*LUCAS COUNTY
PLAN COMMISSION
REPORT*

July 27, 2016

1. Z17-C352: Zone change from A/R and C-2 to R-B and C-1 PUD at 8251, 8339 and 8651 Salisbury Rd and 8300 Maumee Western Rd (bh)

PRELIMINARY DRAWING/PUD
OF
Stoney Creek
MONCLOVA TOWNSHIP,
LUCAS COUNTY, OHIO

PUD DRAWING

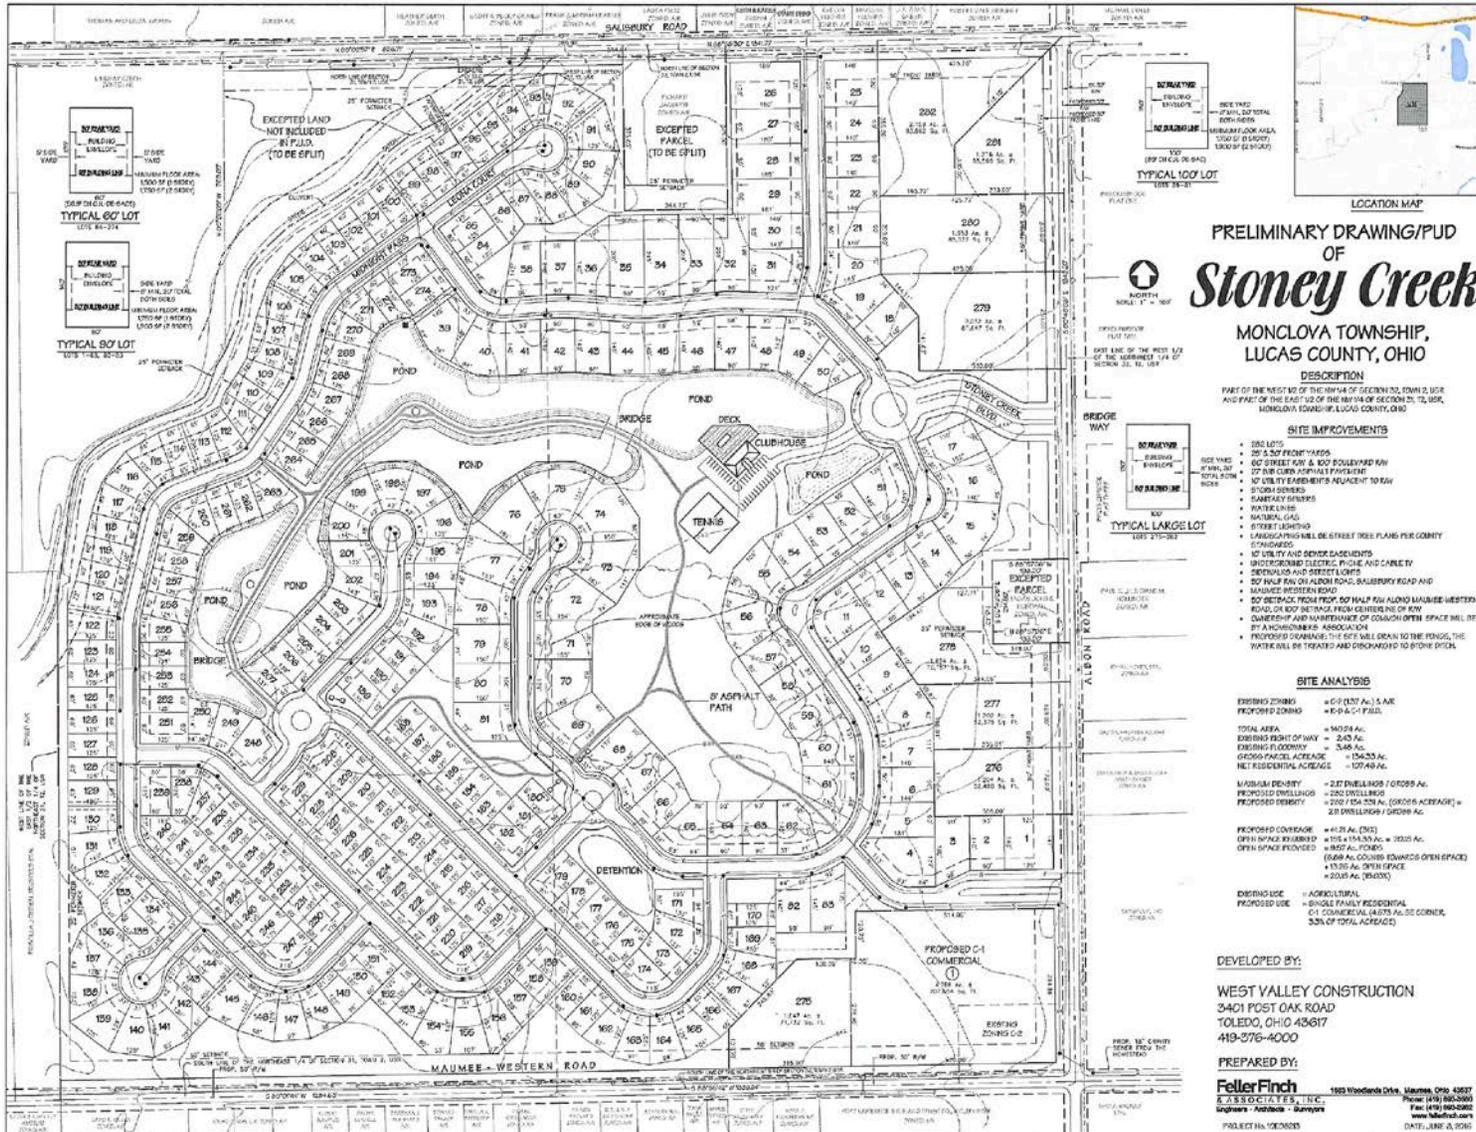
Pursuant to Section 11.5(B)(4) - when a residential area of a Planned Unit Development abuts an "A" or and "R" District, an open space perimeter area shall be provided that has a minimum depth of equal to the required rear yard setback. This open space shall be void of buildings, structures, parking areas, or other above-ground improvements except fencing shall be maintained along all perimeter property lines of the Planned Unit Development. Staff found that the "excluded parcel" west of the Salisbury Road connection will remain zoned A/R Agricultural / Residential and an open space of twenty-five feet (25') is required to be maintained and landscaped. The entire perimeter of the PUD around the "excluded parcel" does not appear to maintain a twenty-five feet (25') setback.

Lots 93 through Lots 123 appears to be partially located within a floodway of “Stone Ditch”. In addition, the floodplain extends across the western half of the property. This could limit the amount and type of development that can take place within these areas, in addition to requiring flood insurance. The applicant indicated that the dirt that is excavated from the proposed ponds will be graded throughout the site to raise the base flood elevation. The Lucas County Engineers office has indicated that while the placement of fill in the floodplain is common to raise the base flood elevation, no development is permitted to take place within a floodway and encourages the applicant to pursue modifying the capacity of Stone Ditch ultimately providing floodway relief to lots 93 to 123.

29. The 100 year floodplain for Stone Ditch is not shown on the plan. Development within the Stone Ditch floodplain and floodway shall comply with Lucas County and F.E.M.A. regulations. Minimum first floor elevations shall be at least one foot above the 100 year flood elevation for Stone Ditch. If widening or re-alignment of Stone Ditch is proposed, additional permits may be required from the US Army Corps of Engineers and Ohio EPA.

41. Some roads are unlabeled on the submitted drawing. Road names shall be submitted for approval by Monclova Township Fire.
42. The large lots 275-282 that do not have street access through the interior subdivision roads must follow all access management guidelines and requirements.
43. Per section 11.5 C 2 b. of the Monclova Township Zoning Resolution regarding the portion of the property proposed for C-1 Commercial zoning "A minimum open space distance of 75 feet shall be provided when abutting an "A" or "R" District."
44. Location of any monument signs should be shown.

45. Regarding the Clubhouse area location of handicapped parking as well as the dimensions of the deck and clubhouse and tennis court should be shown on the site plan.
46. A landscape plan shall be provided.
47. Information should be provided to indicate that the proposed lots that back up to or are facing Maumee-Western Road conform with the US 20A Maumee-Western Rd. Overlay District in regards to required setbacks.

48. Road names are not been depicted on the submitted drawing. Road names to be submitted for approval by Monclova Township Fire.
49. Roads are to be substantially complete or approved temporary access to building construction sites provided prior to combustible materials being brought on site.

52. Drawing shows hydrants in the center of cul-de-sac streets. Developer to work with the fire department on hydrant locations.
53. If the development is to be built in phases, approved turn arounds meeting Lucas County standards shall be installed. These turnarounds shall be approved by the Fire Chief and Road Superintendent of Monclova Twp.

58. The southern property line along US 20A is part of a larger PUD and should require a minimum of twenty-five feet (25’) of landscaping along the entire US 20A frontage. Lots 162 – 165 will need to be reconfigured to accommodate this area and additional right-of-way.
